T.I. no.: 2020 - 02 Updated: -	Topic: Additional powder container outlet restrictor
-----------------------------------	--

ADDITIONAL POWDER CONTAINER OUTLET RESTRICTOR

EX-WORKS: CHOC PLATE (33.2293.700)

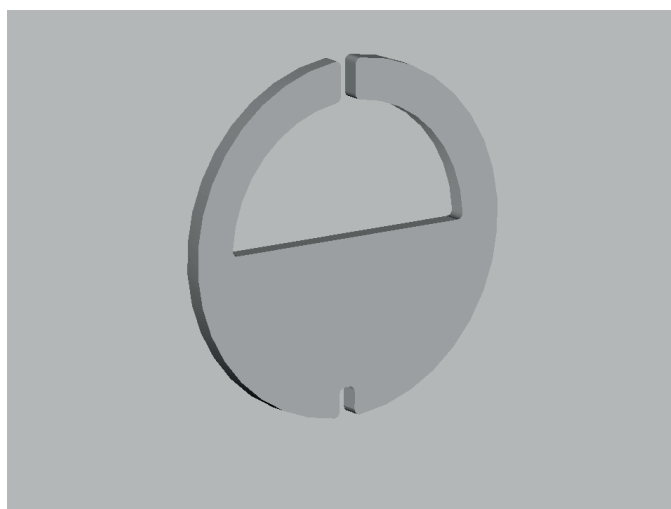
The powder can become clogged with the previously installed powder container outlet restrictor (079940).

The Choc plate (33.2293.700) is installed ex-works and the powder container outlet restrictor (079940) is also included. In case of problems, the service technician can change them on site.
